Planning and Zoning Commission

March 2, 2021

RE: South James Plat 1 Preliminary Plat

RE: Christian Brothers Auto Site Plan

5 FRONT ELEVATION
SCALE: 3/16" = 1'- 0"

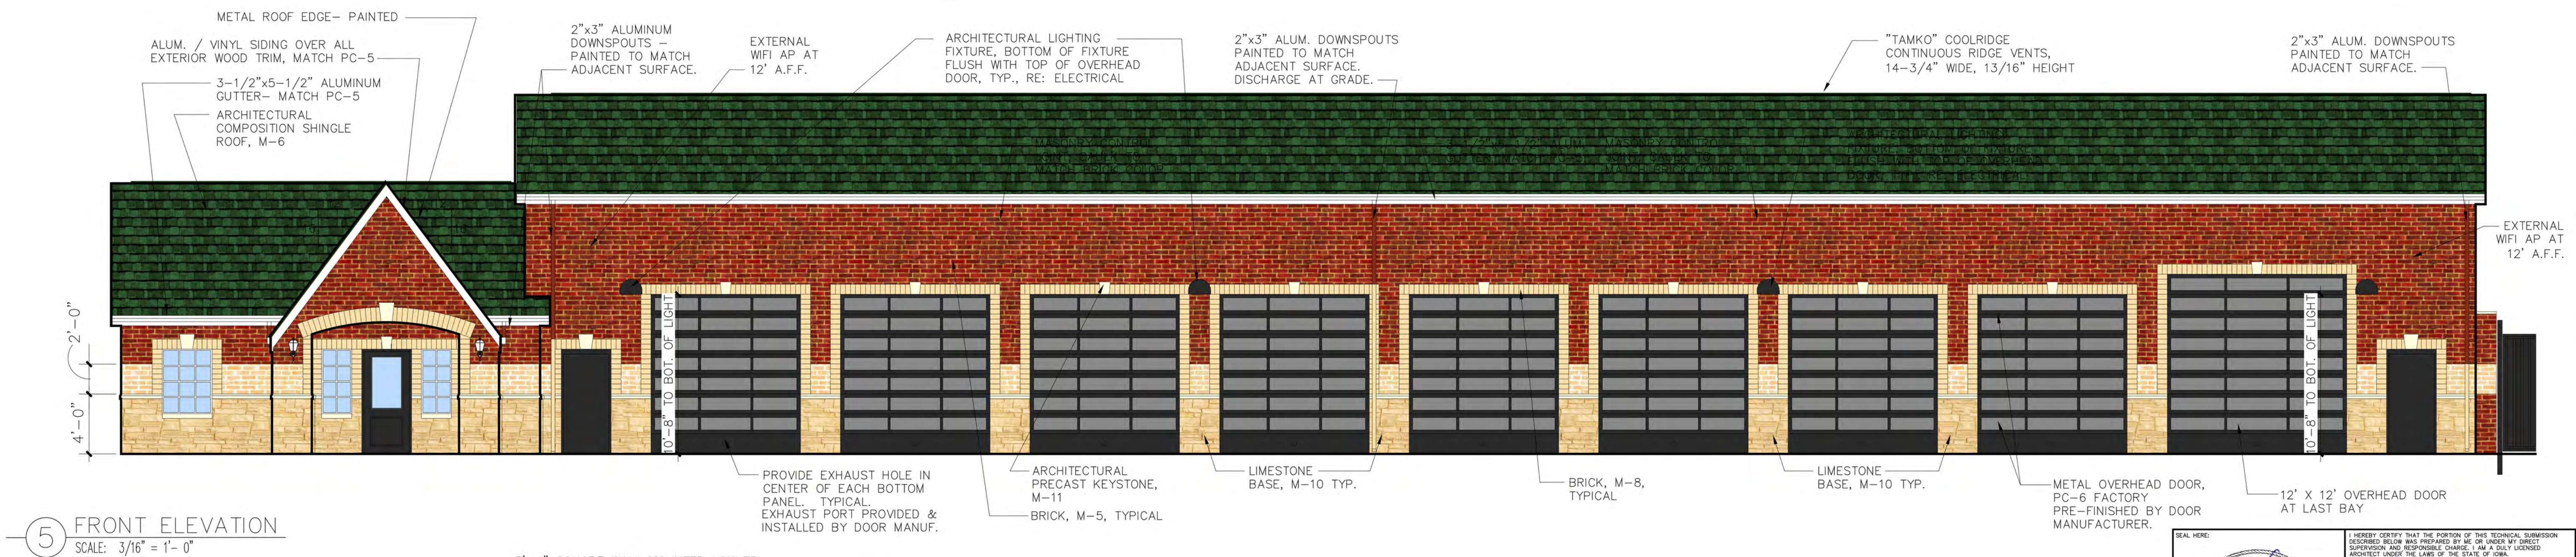
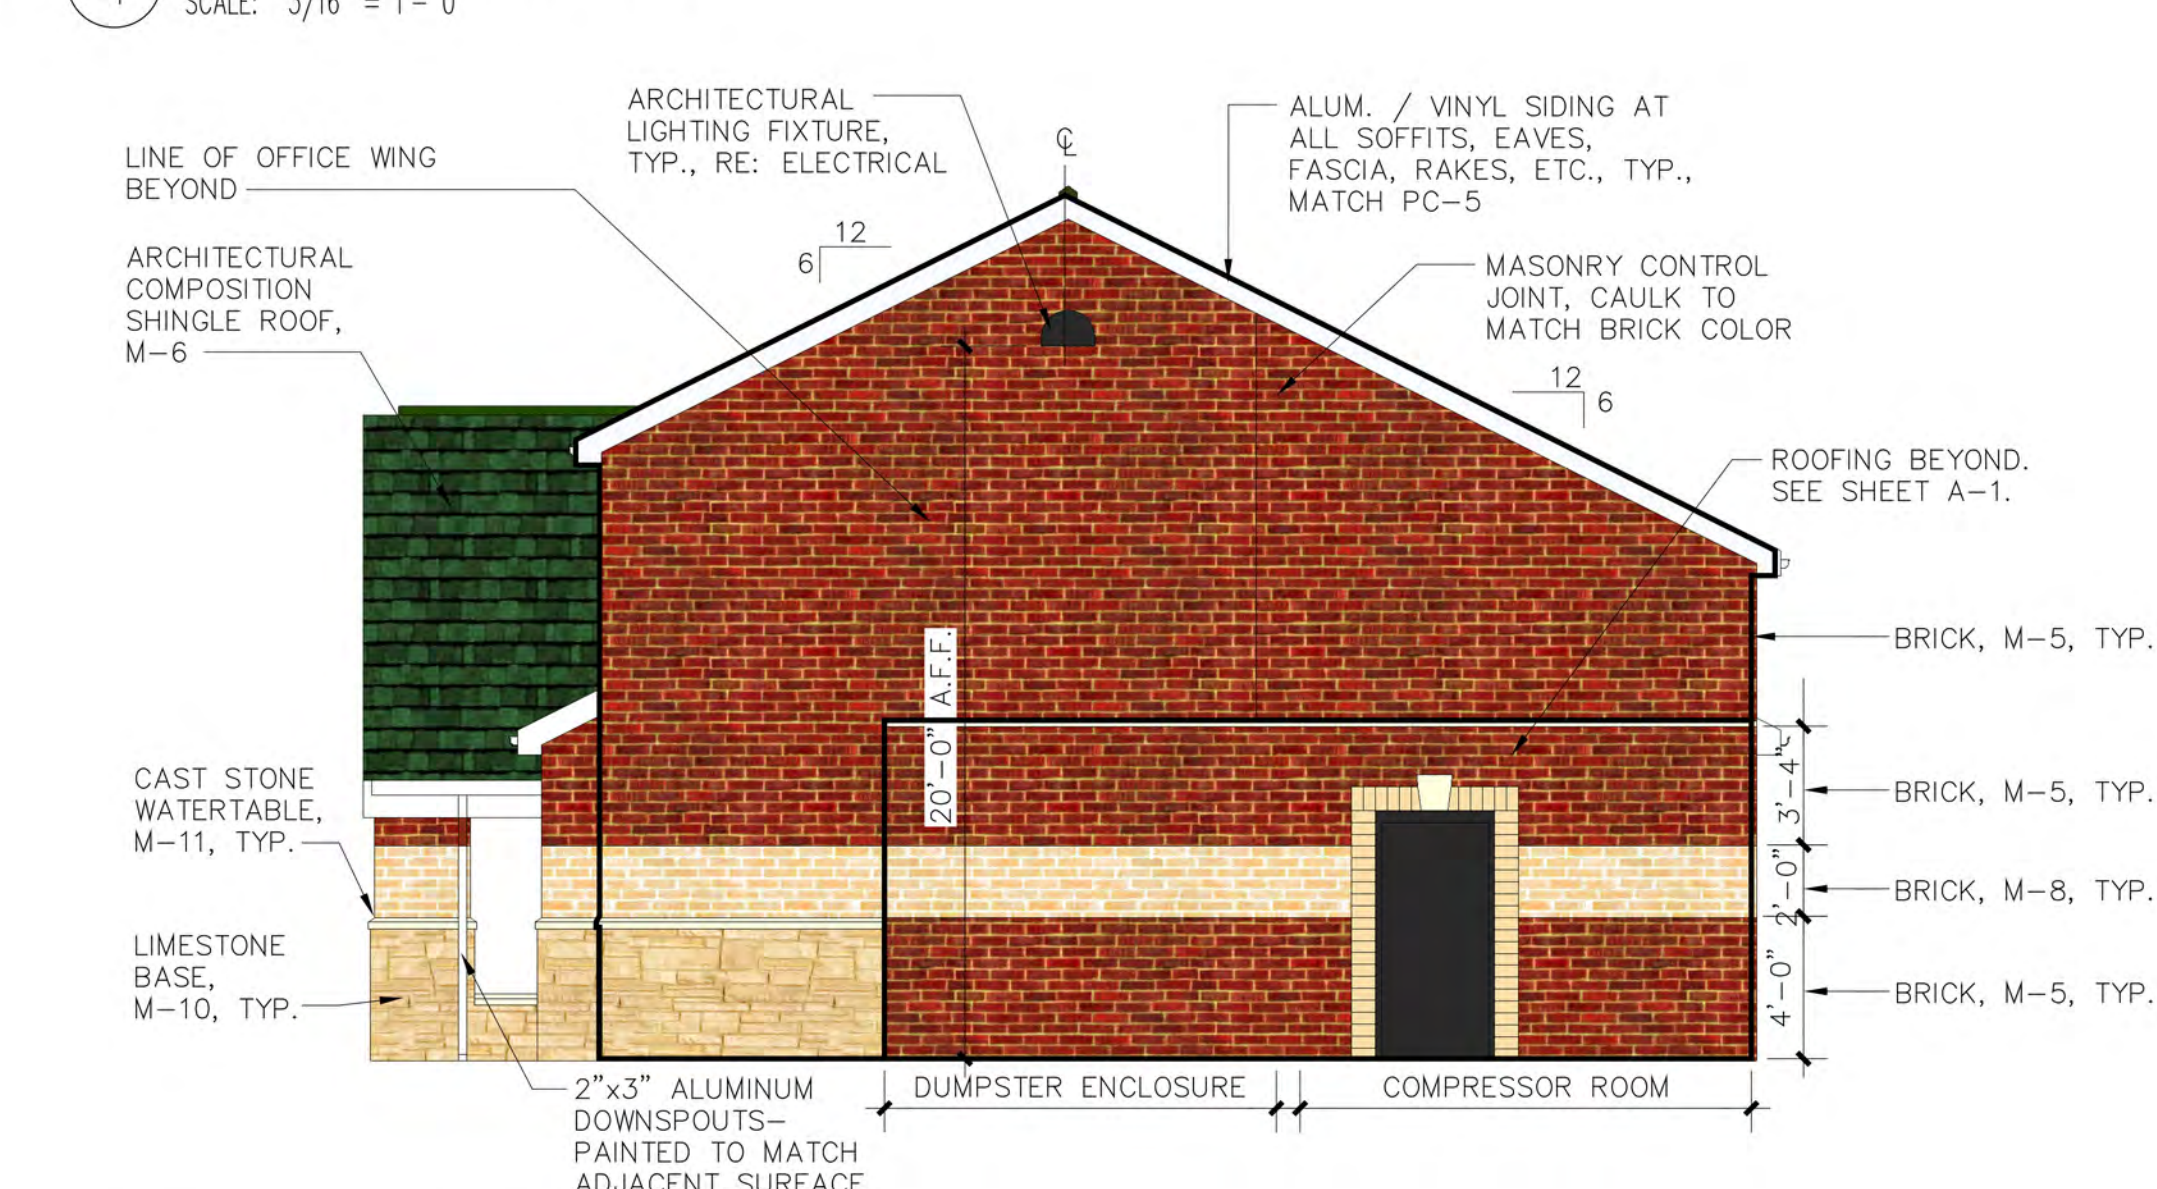
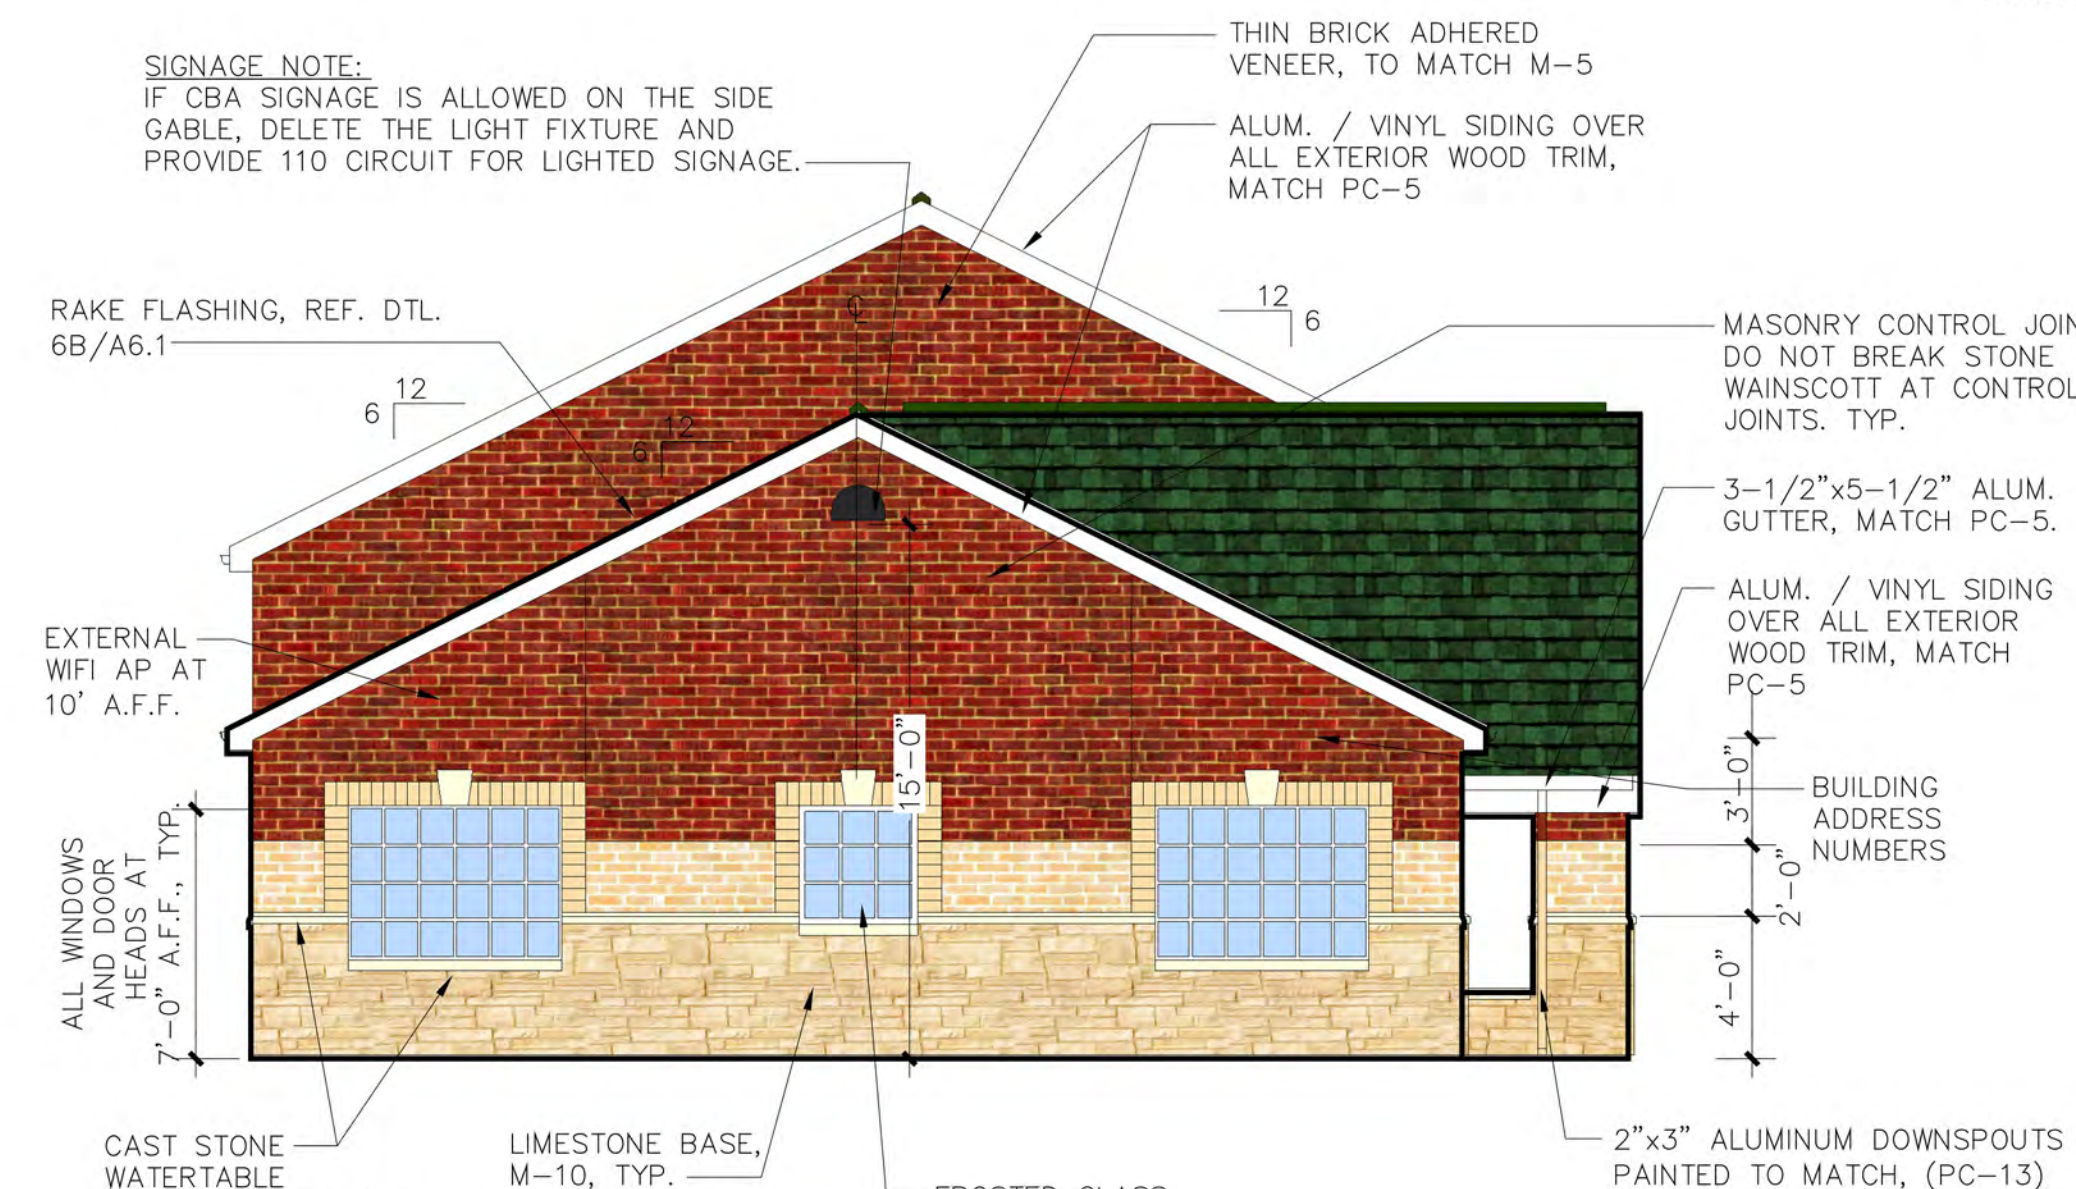
- ~~1. Provide building elevations.~~
- ~~2. Provide building lighting cut sheets.~~
3. Please provide additional architectural details on the west elevation to preserve building scale and reduce the negative aesthetic impact of long, large, expansive wall surfaces.

4. Is roof mounted equipment proposed? If so, please show on elevations and provide screening.
5. Some of the labels are shown over the roof and are hard to read. Please move or edit the labels to make them legible.

6. Please make the roof shingles black to match the doors and overhead doors.
7. Provide material percentages.
8. Provide glazing percentages. 40% of the wall length at eye level should be clear glass.
